Coso Operating Company Hay Ranch Water Extraction and Delivery System

Conditional Use Permit (CUP 2007-003) Application SCH# 2007101002

Final EIR Inyo County, California

December 2008

Figure ES 1-1: Project Location

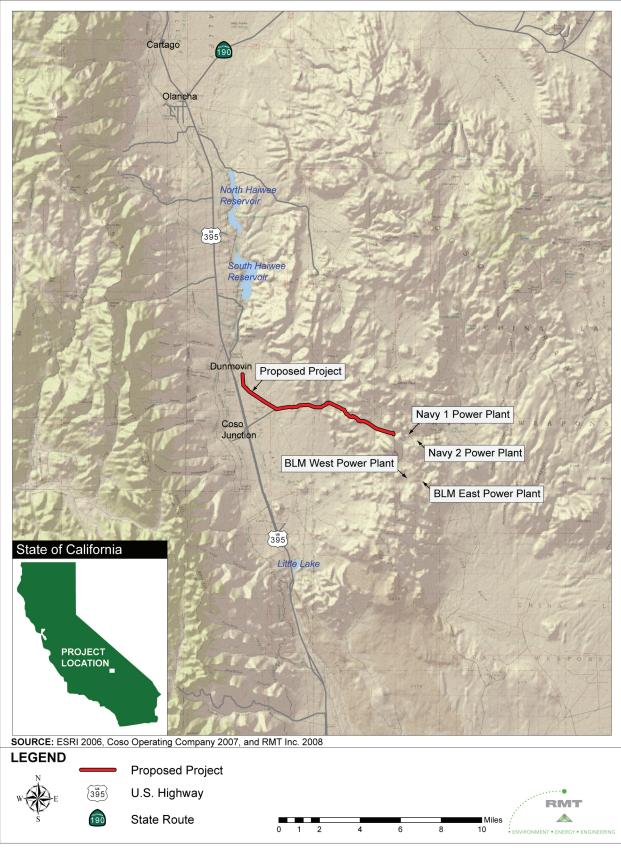
Figure ES 1-1: The schematic only shows Navy 1 and Navy 2 power plants. Where is the power plant and why is it not included?

- P3-15 The change was made as requested for the purpose of clarification. The figures have been modified to show the BLM East and BLM West power plants. (Figures ES 1-1, ES 1-2, 1.1-1, 2.3-1, 4.2-1, and C4-1). Figure revisions are shown in Section 3.4 of this Final EIR. These power plants were accidentally omitted from the maps, even though they were described in the text. The addition of the location of these power plants does not constitute significant new information that would require recirculation of the EIR.

The following figure has been modified to show the BLM East and BLM West power plants at the Coso geothermal field.
